SUBJECT: ISSUANCE OF AMENDMENTS FOR THE PALO VERDE NUCLEAR GENERATING STATION
UNIT NO. 2 (TAC NO. M89800)

AMENDMENT TO FACILITY OPERATING LICENSE

Amendment No. 65
License No. NPF-51

SAFETY EVALUATION BY THE OFFICE OF NUCLEAR REACTOR REGULATION
RELATED TO AMENDMENT NO. 65 TO FACILITY OPERATING LICENSE NO. NPF-51,
ARIZONA PUBLIC SERVICE COMPANY, ET AL.
PALO VERDE NUCLEAR GENERATING STATION, UNIT NO. 2
DOCKET NO. STN 50-529

FIGURE 3.2-1

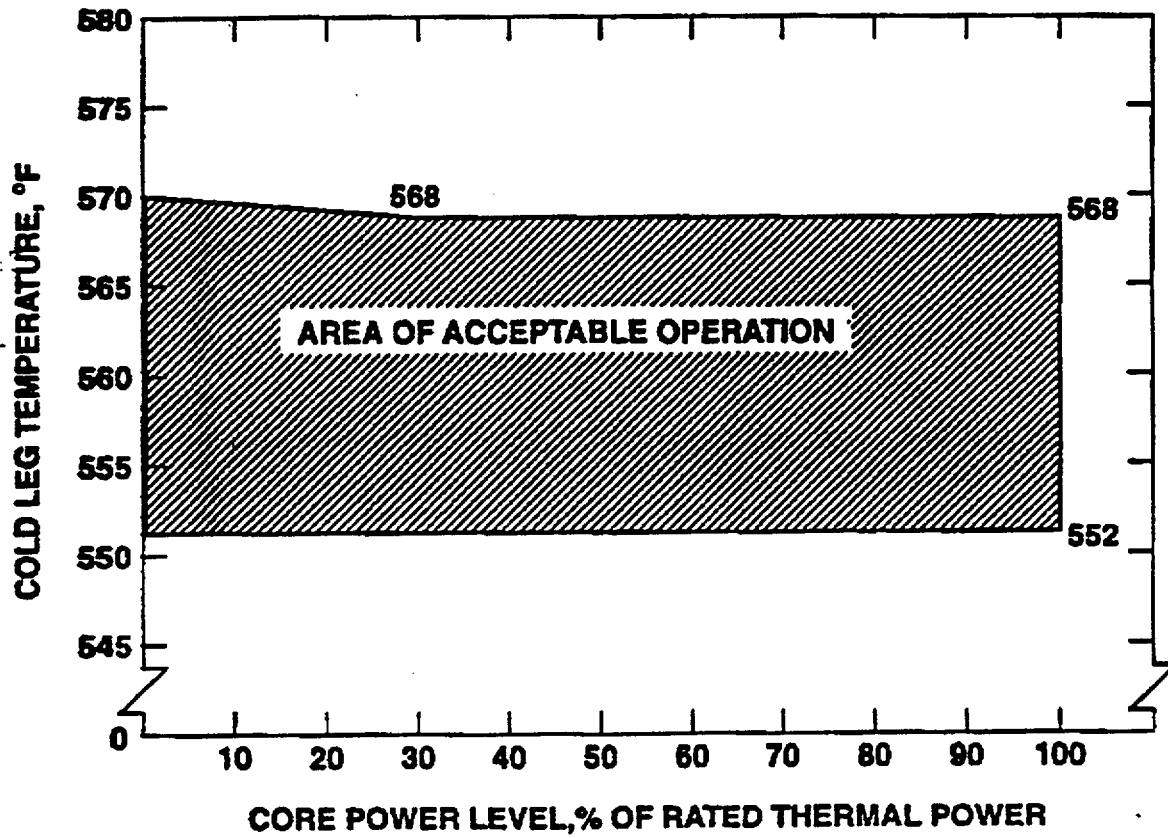
The proposed amendment changes the minimum cold-leg temperature for core power levels between 90% and 100% to 552 °F for Unit 2 (which is a reduction of 10 °F from the previous TS requirement). This TS change permits reactor operation at full power with a lower reactor coolant temperature to minimize potential steam generator tube degradation. The cold-leg temperature reduction at power levels above 90% was previously granted for Units 1 and 3 by letter dated June 7, 1994.

The cold-leg temperature reduction at power levels above 90 percent was previously granted for Units 1 and 3 by letter dated June 7, 1994. The change was not requested for Unit 2 due to continuing analysis arising from steam generator tube plugging in that unit. Currently, Figure 3.2-1 of the Palo Verde Unit 2 TS specifies a minimum cold-leg temperature of 562 °F for core power levels between 90 percent and 100 percent. This TS requirement is supported by the safety analyses documented in the Updated Final Safety Analysis Report (UFSAR). Operation of Palo Verde Unit 2 is currently restricted by an administratively imposed 10 °F reduction in the reactor coolant cold-leg temperature, by maintaining reactor power at approximately 88 percent of rated core power to satisfy the current TS requirements. The licensee requested a change to the TS to allow Unit 2 to operate at full power

with a 10 °F deduction in the reactor coolant cold- and hot-leg temperatures. The hot-leg temperature reduction is needed to minimize the steam generator tube degradation (e.g., PWSCC).

3.2.6 The reactor coolant cold leg temperature (T_c) shall be within the Area of Acceptable Operation shown in Figure 3.2-1.

In summary, based on the results of the Unit 2 cycle-specific evaluations and the evaluations discussed above, a 10 °F reduction in cold-leg temperature is acceptable for Unit 2. The staff has reviewed the licensee's submittal and finds that the proposed TS change is supported by appropriate analysis and is acceptable.
